State Significant Development 7664

Horsley Drive Business Park Stage 2
Section 4.55(2) Modification Application

Submitted to Department of Planning, Industry
and Environment
On behalf of Charter Hall

17 June 2020 | 2190880

Figure 1 Proposed Plan of Subdivision

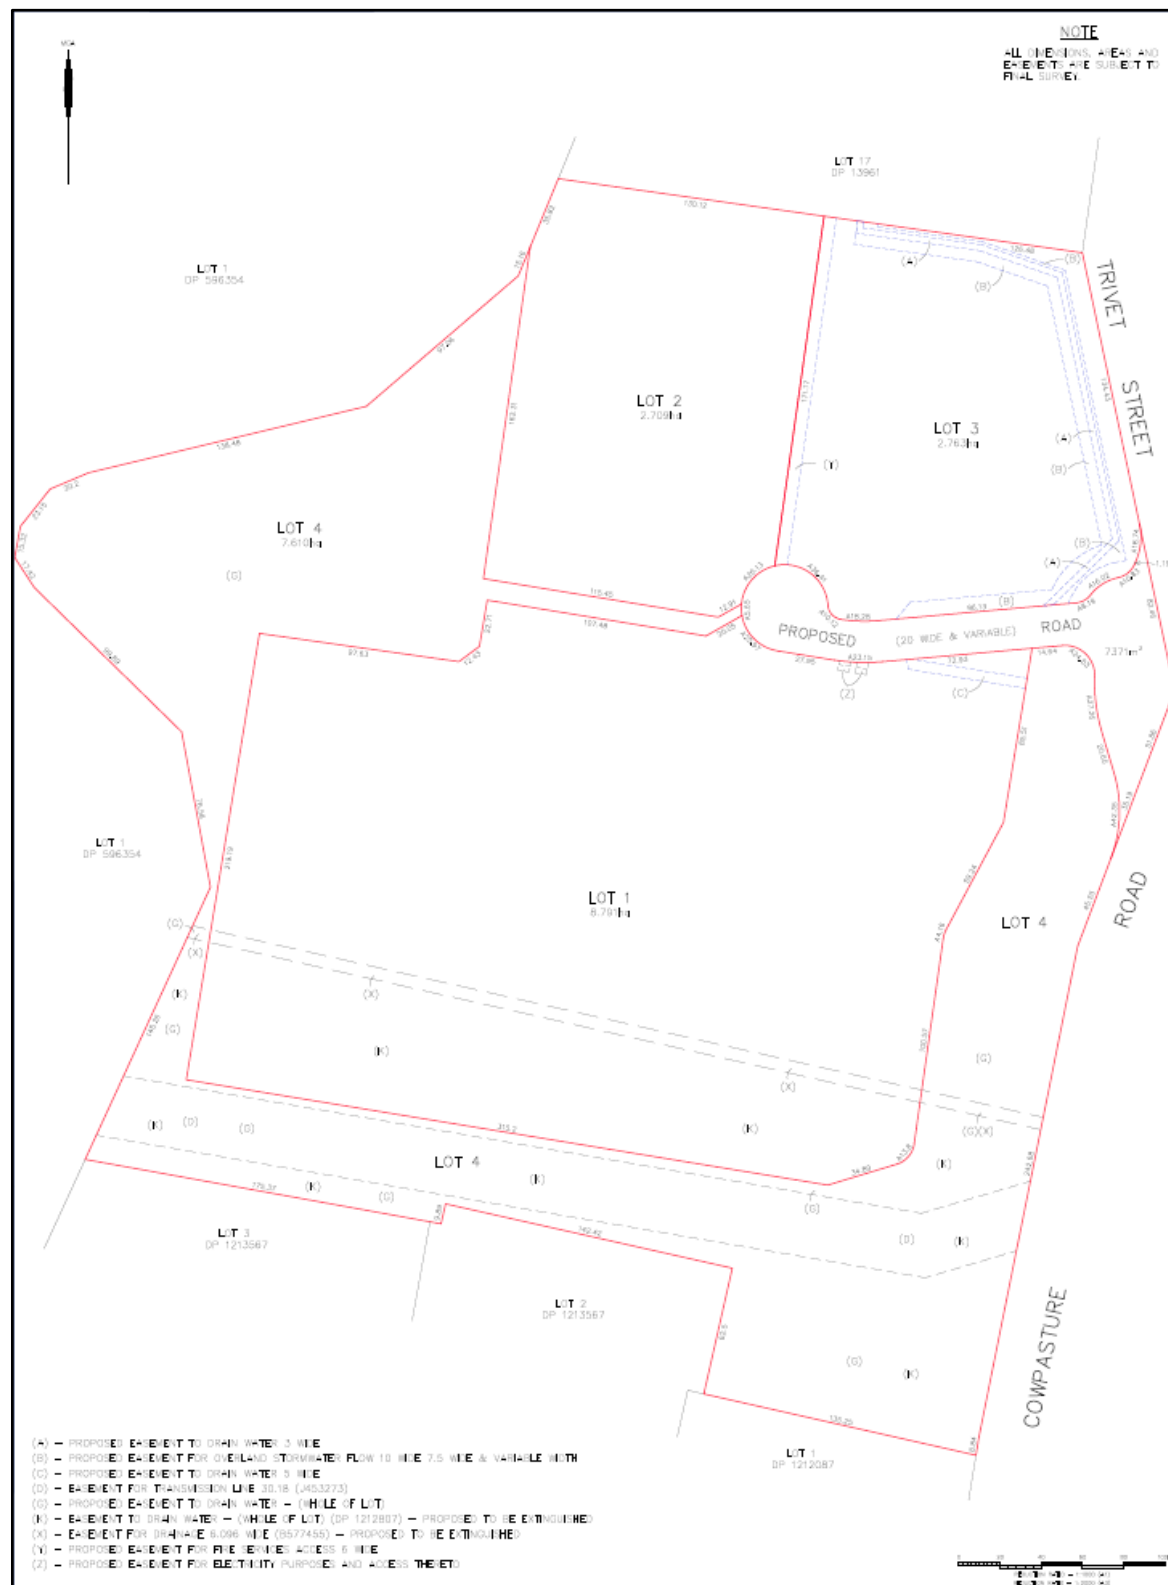
4. *confirm if lot consolidation is being sought under SSD 7664 MOD 1. If so, the amended site plan should reflect this and a plan of consolidation, provided.*

Lot consolidation is being sought under SSD 7664 MOD 1.

The existing lots that form part of approval SSD 7664 include Lots 17-22 DP 13961 and Lot 2 DP 1212087.

As demonstrated on the Proposed Plan of Subdivision Plan submitted with the Modification Application (SSD 764 MOD 1) and detailed below in **Figure 1**, the proposed modification seeks to consolidate the existing 7 lots into 4.

The overall site plan (DA02) prepared by Leffler Simes Architects has been amended to reflect this consolidation (**Appendix B**).
